GE Hitachi Nuclear Energy

Subject: GEH License Amendment Request – Permanent Cessation of the GE Nuclear Test Reactor (NTR) and Possession Only Authorization

R-33 License Proposed Technical Specifications

NEDO 32765
Revision 7
October 2023

Figure 1 Typical Rod
Drive Power
(Simplified)

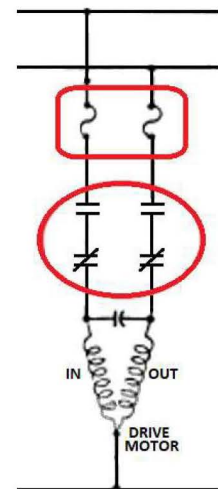
The control and safety rods are fully inserted and restrained in the reactor by removing their drive motor linkages and isolating their motors electrically by removing inline fuses and relays (See Figure 1). Proposed TS surveillance 4.2.1 periodically verifies that rod configuration remains consistent with the POLSC.
